Finch Hollow Watershed Project, Site 1. Inventory Number NY-697
Susquehanna River Basin. Broome County,
New York. Phase 1 Inspection Report,

SUSQUEHANNA RIVER BASIN
FINCH HOLLOW WATERSHED PROJECT - SITE I
NY 697
PHASE I INSPECTION REPORT

PHASE I REPORT
NATIONAL DAM SAFETY PROGRAM

Name of Dam: Finch Hollow Watershed Project - Site 1
I.D. No. NY 697

Right Side of Principal Spillway Riser
Photo #3

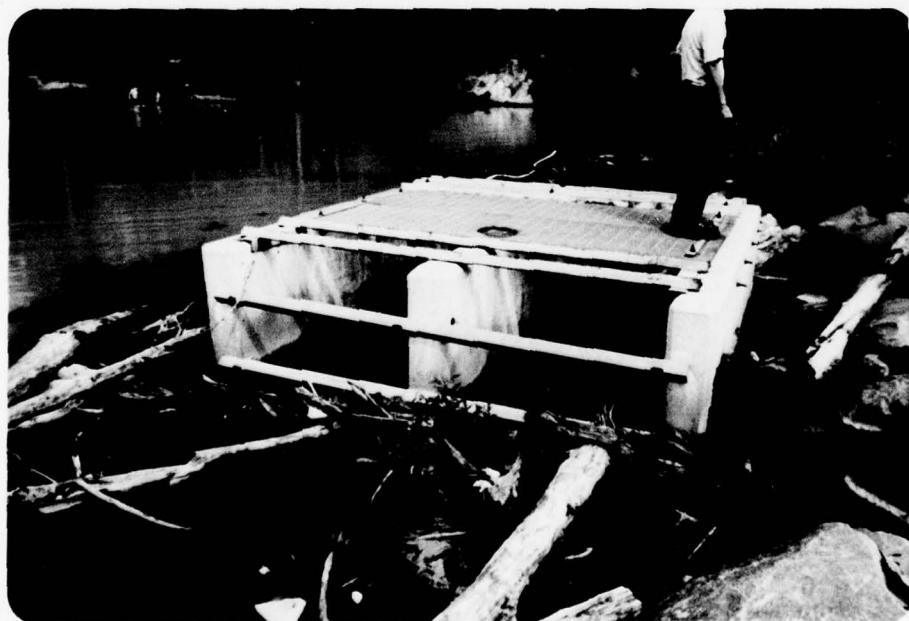
1. The riser top grating is loose and the bolting units require repair. (See photo #5);
2. Considerable debris is surrounding the intake of the principal spillway. This debris should be removed with periodic removals conducted in the future. (See photos #3 & 4).

1. Remove the tree growth at the entrance and exit of the auxiliary spillway channel to permit the unimpeded flow of discharge water;
2. Repair the bolting units of the principal spillway riser grating;
3. Remove the debris surrounding the principal spillway riser intake. Provide a program of periodic inspection and maintenance of the dam and appurtenances, including operation and lubrication of the slide gate mechanism. Document this information for future reference;
